ADDENDUM NO. 1

Date of Addendum: 4/20/16

PROJECT NAME: Clearwell Condition Assessment and Replacement of Select Valves and Actuators at the EWPP

PROJECT NO: WBS No. S-000056-0070-4

DATE	FOR CITY OF HOUSTON USE ONLY
FEBRUARY 2016	
WBS NUMBER	
S-000056-0070-4	
CITY OF HOUSTON PM	
JOHN MSIGWA, P.E.	
DRAWING NO. G05	
SHEET NO. 05 OF 73

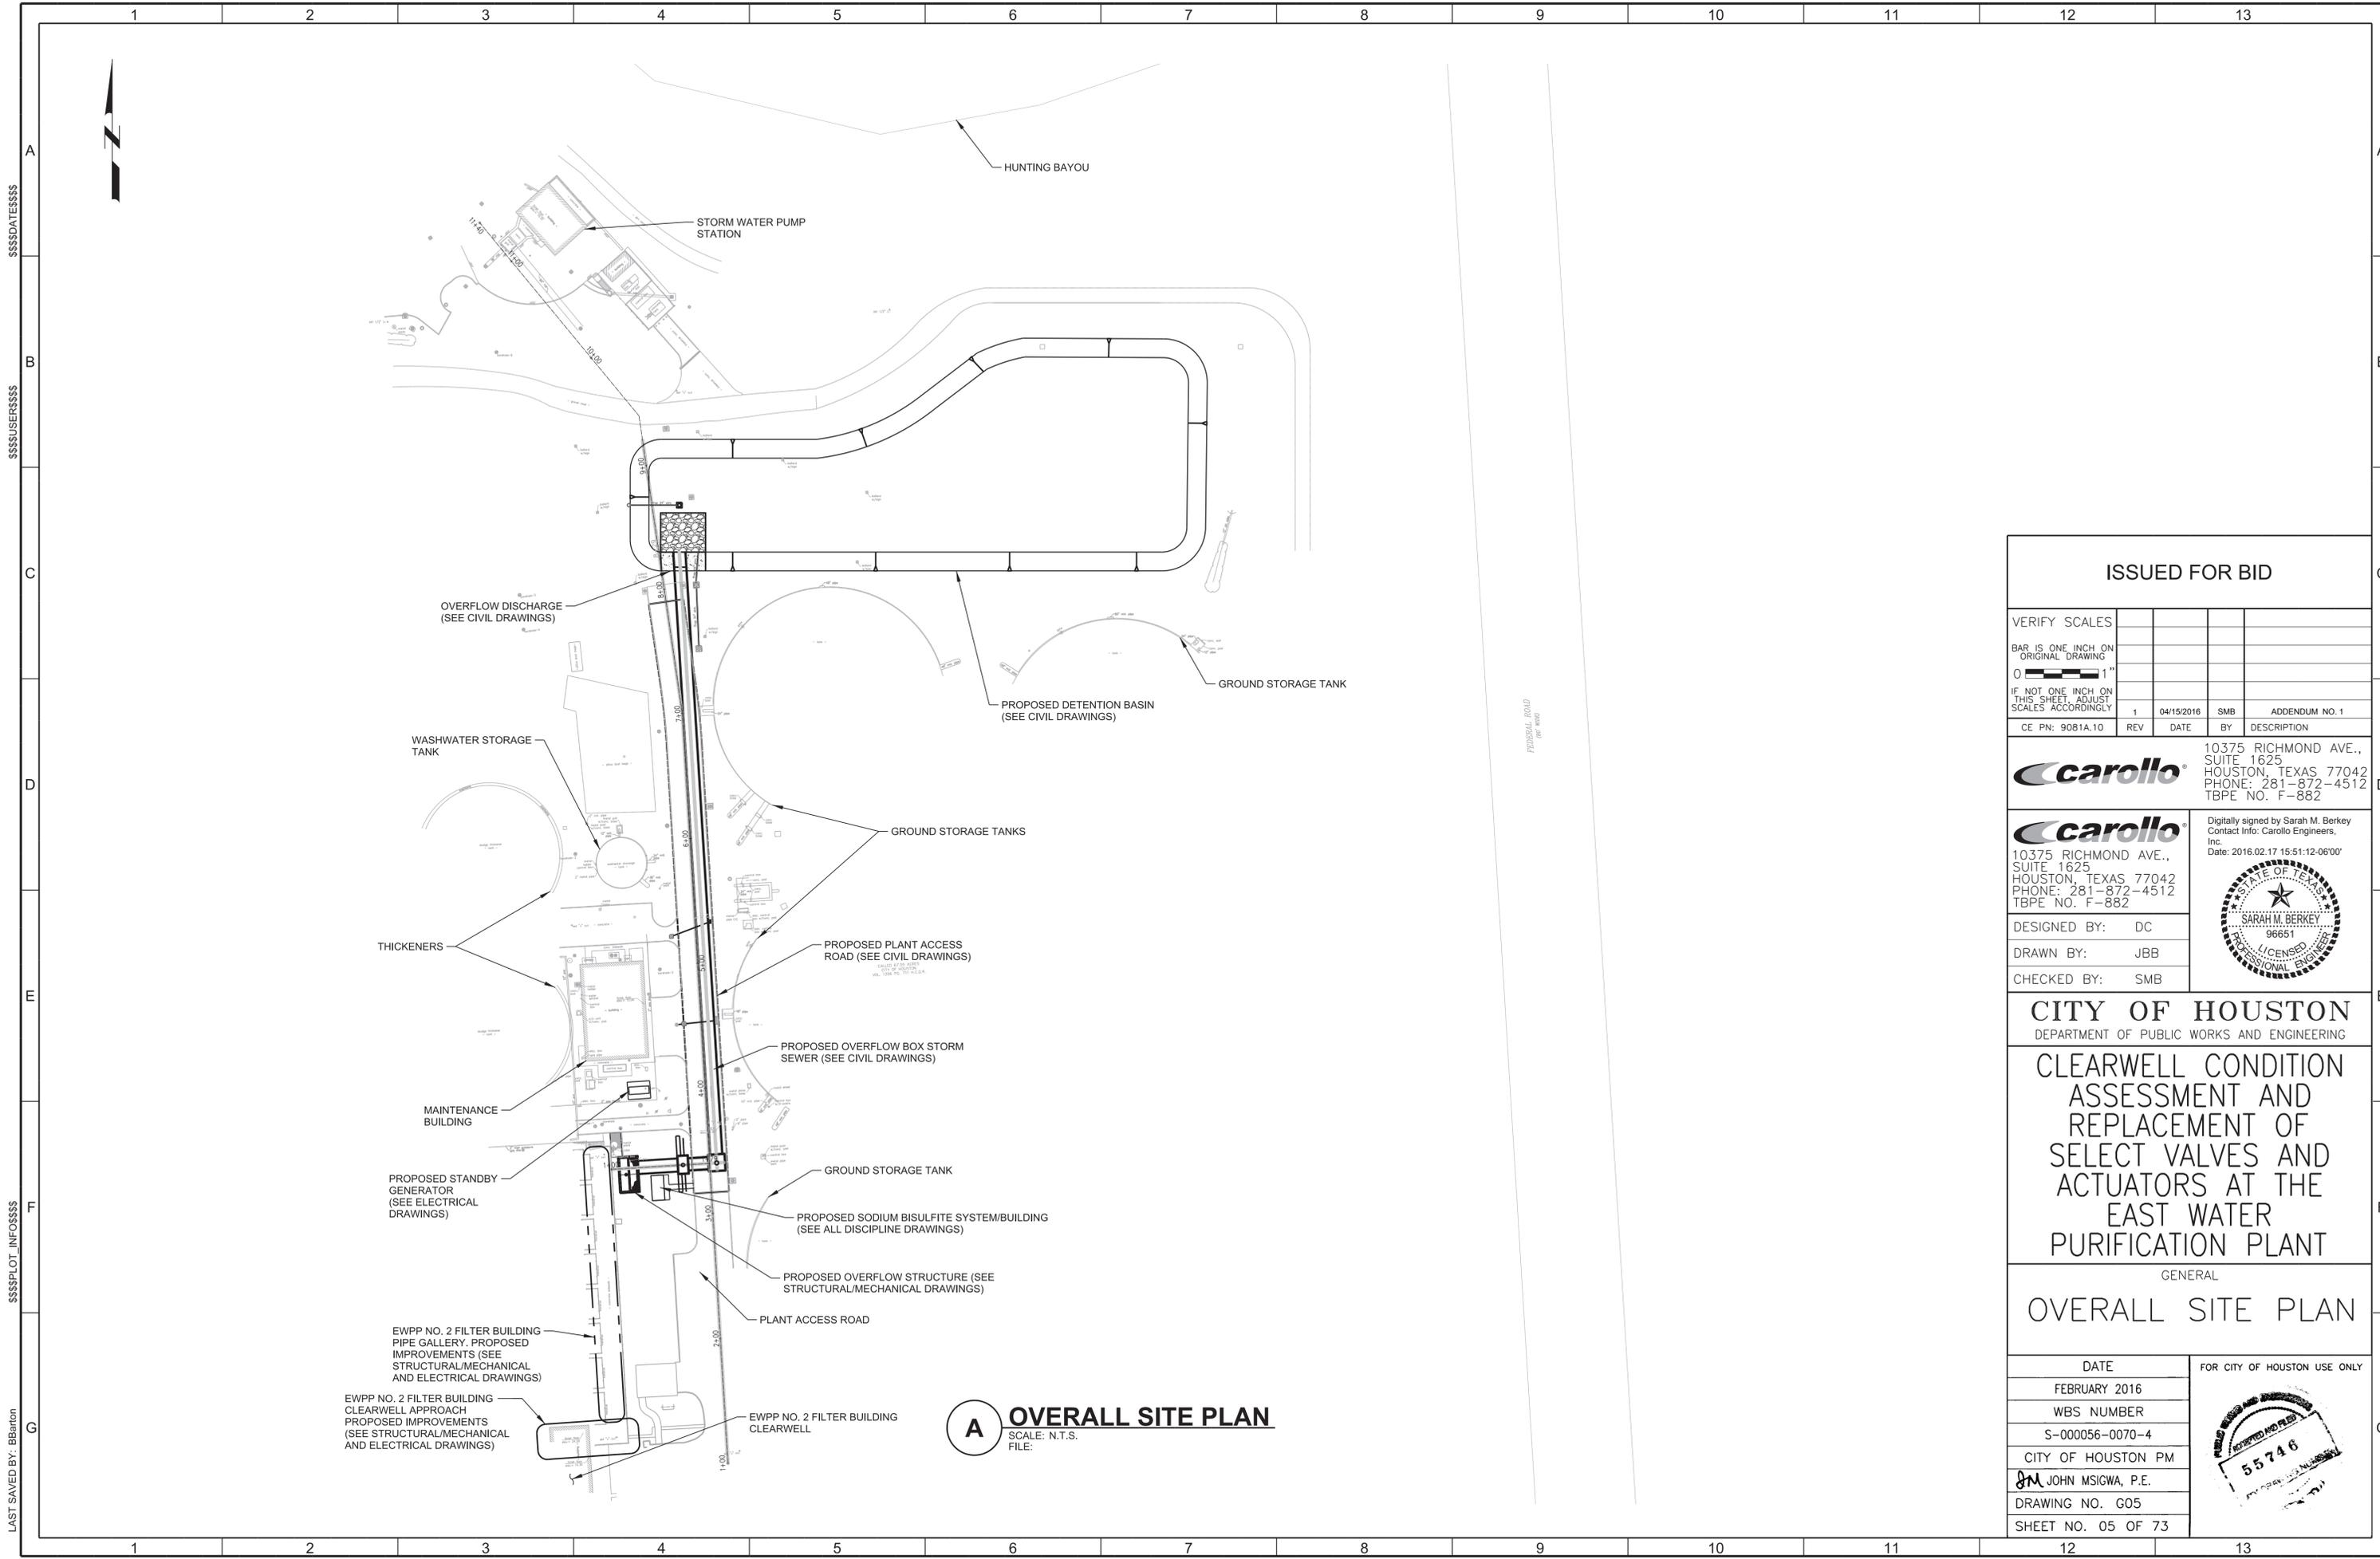
1. Sheet G01, Cover Sheet. Replace sheet with G01, attached.
2. Sheet G05, Overall Site Plan. Replace sheet with G05, attached.
3. Sheet G06, Hydraulic Profile. Replace sheet with G06, attached.
4. Sheet C01, Demolition Plan. Replace sheet with C01, attached.
5. Sheet C02, Site Plan. Replace sheet with C02, attached.
6. Sheet C03, Horiz. Control Plan (Sheet 1 of 2). Replace sheet with C03, attached.
7. Sheet C05, Roadway Plan & Profile. Replace sheet with C05, attached.
8. Sheet C06, Roadway Sections. Replace sheet with C06, attached.
9. Sheet C07, Box Storm Sewer P&P @ STA 1+00 to 6+00. Replace sheet with
